GRASSING PLAN-2
North-South Road
Phase 1A
F.A.I. Proj. No. STP-8930(1)

North-South Road
Phase 1A
F.A.I. Proj. No. STP-8930(1)

-/-	FIELD ORDER 7
DATE	REVISION
STATE OF HAWAII DEPARTMENT OF TRANSPORTATION HIGHWAYS DIVISION GRASSING PLAN-4 North-South Road Phase 1A F.A.I. Proj. No. STP-8930(1)	
Scale: As Noted	Date: Dec 22, 2004
SHEET No. L1.4 OF 4 SHEETS

GRASSING PLAN - 4
SCALE: 1"=40'

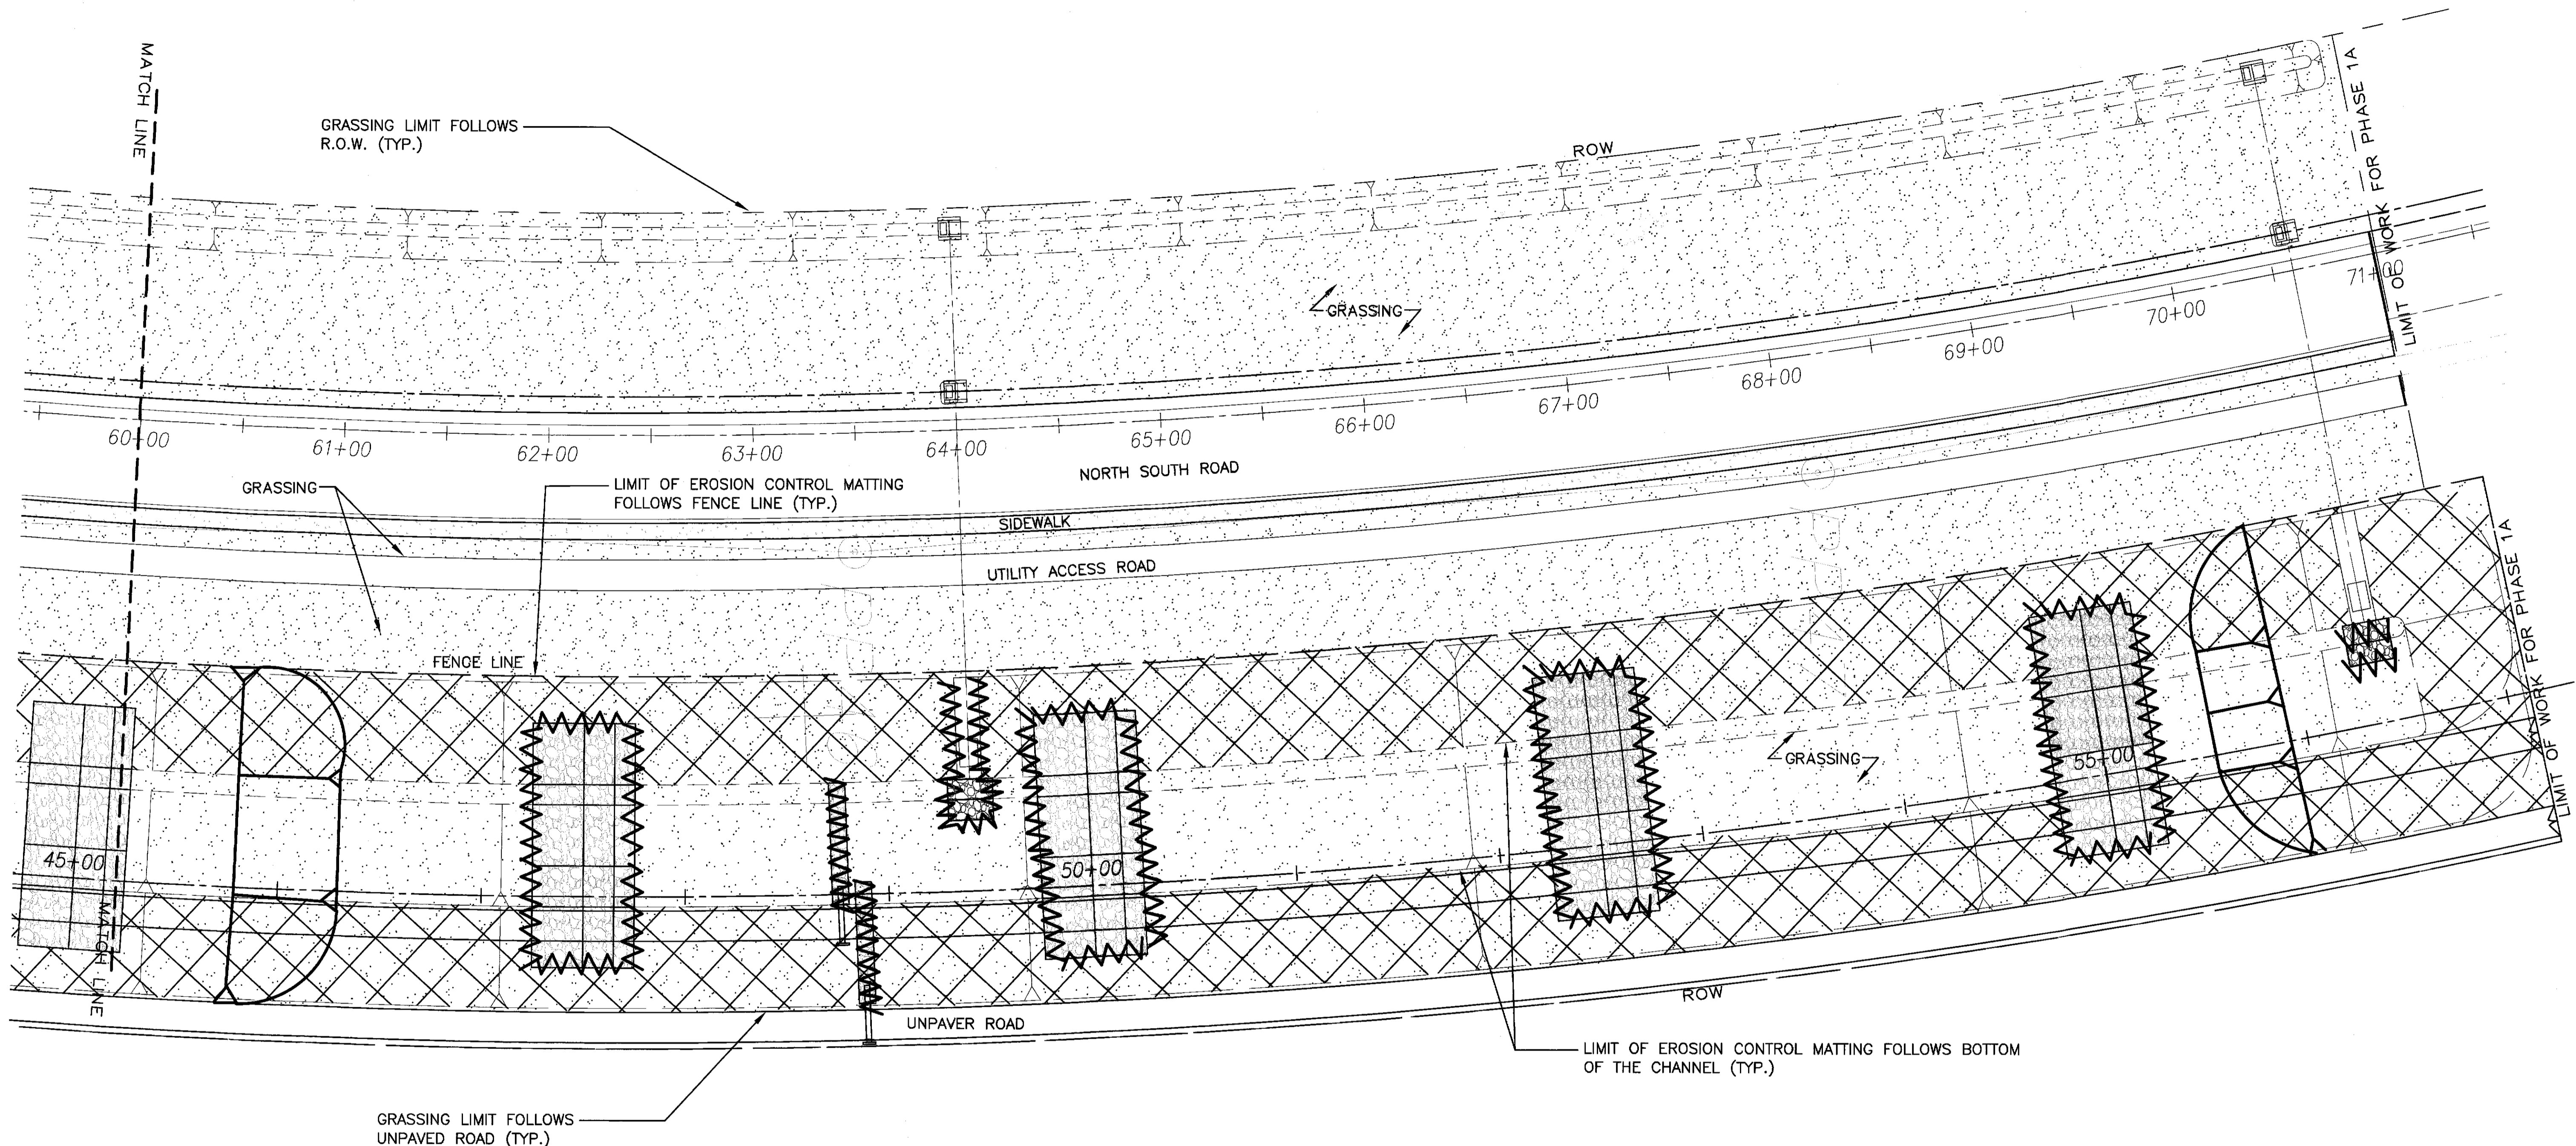
EROSION CONTROL MATTING AS WELL AS DRAINAGE CHANNEL EXCAVATION, FILTER ROCK BERMS, GRP APRONS AND CULVERT F OUTLET DELETED IN THIS AREA
